ATTACHMENT 3

PROPOSED TECHNICAL SPECIFICATIONS

Marked Up Technical Specification Pages:

CORE OPERATING LIMITS REPORT

FIGURE 2.1-1

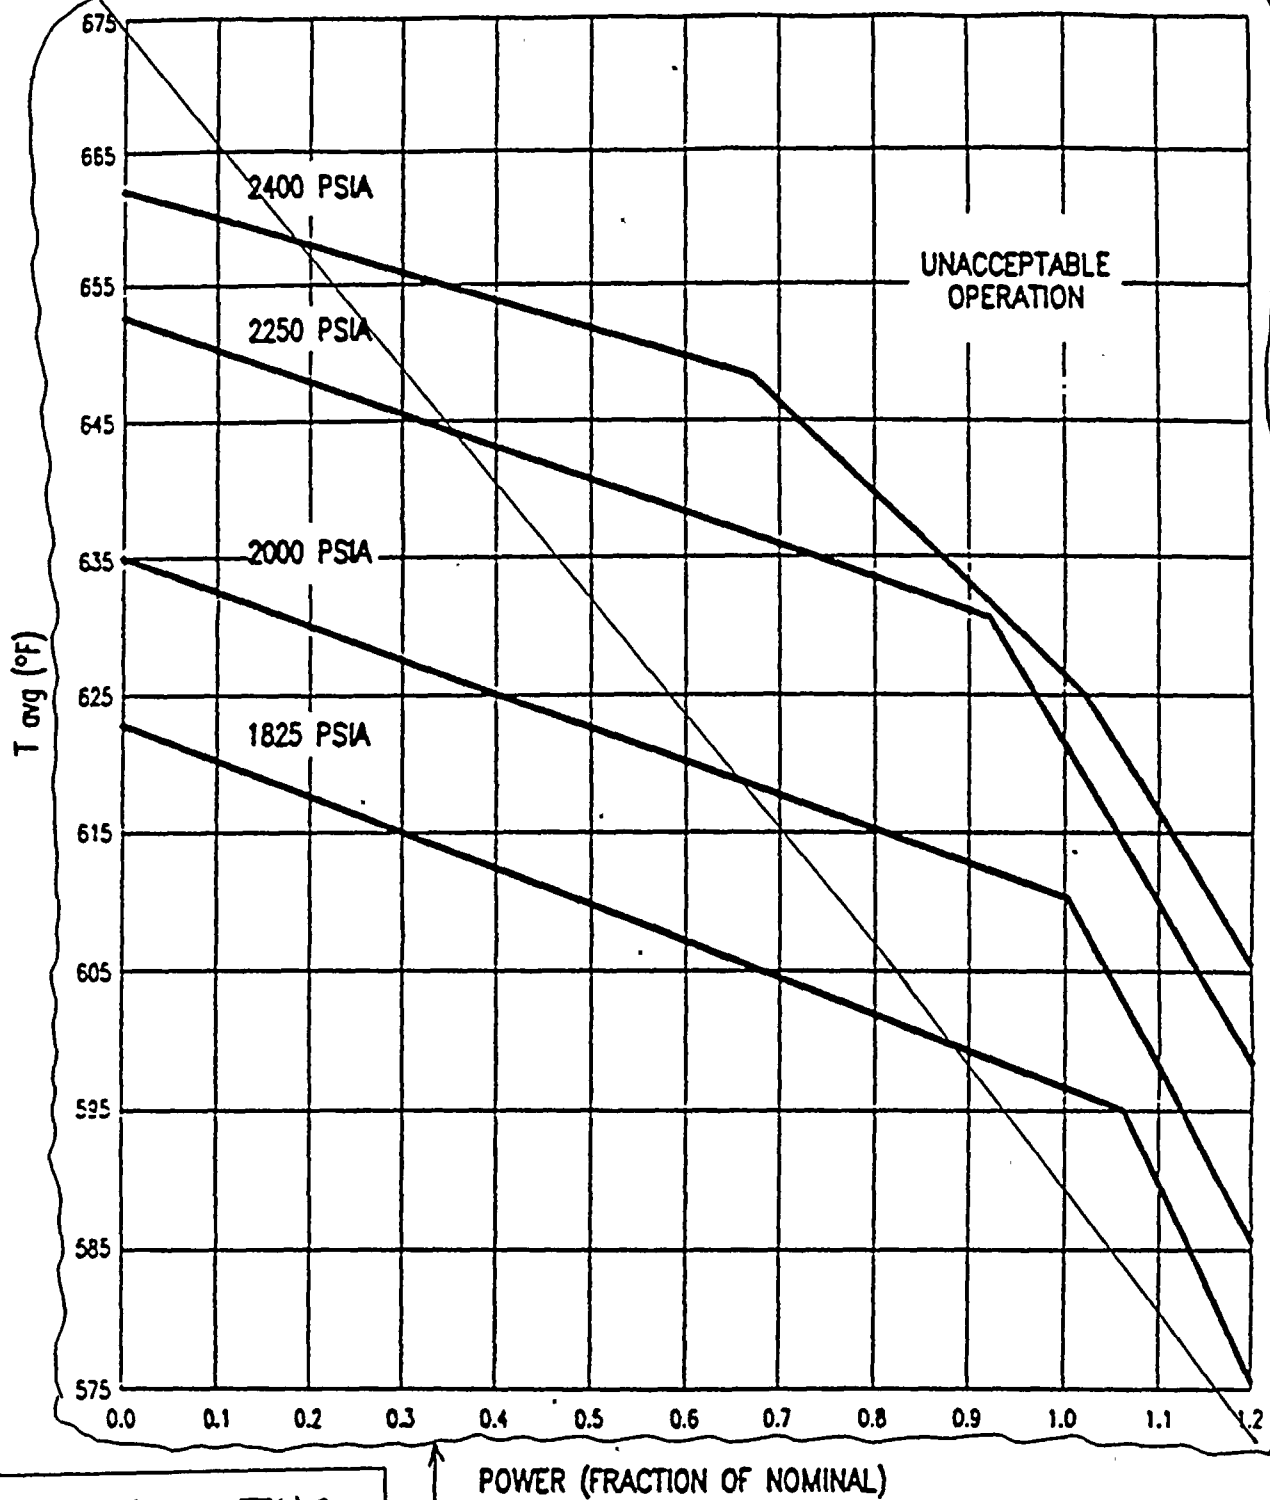
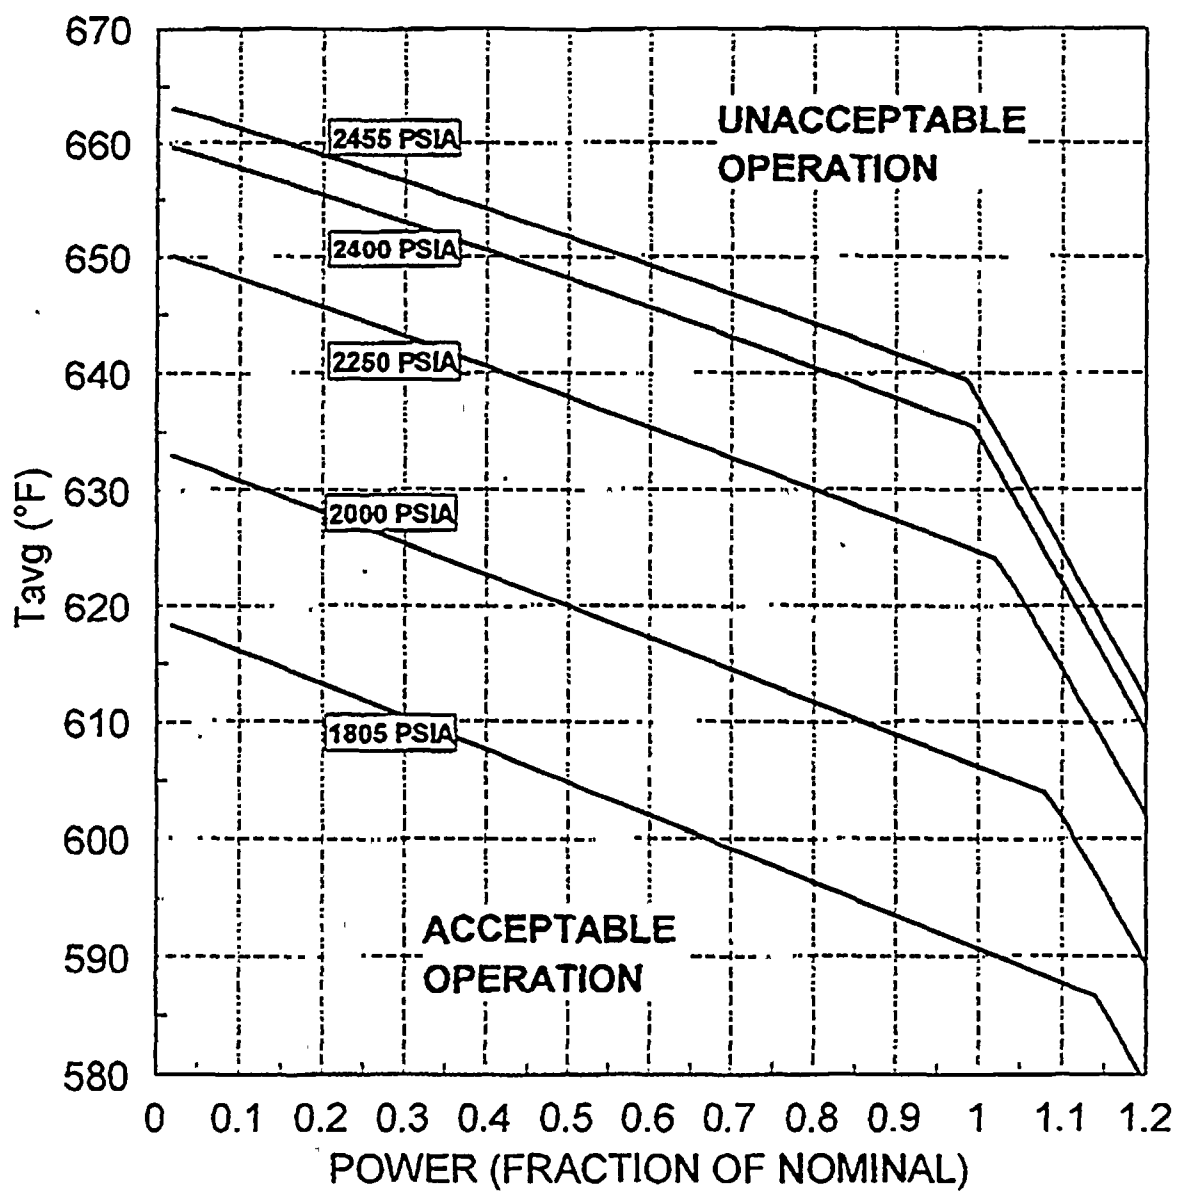
SUBSTITUTE THE
ATTACHED FIGURE
FOR THIS FIGURE
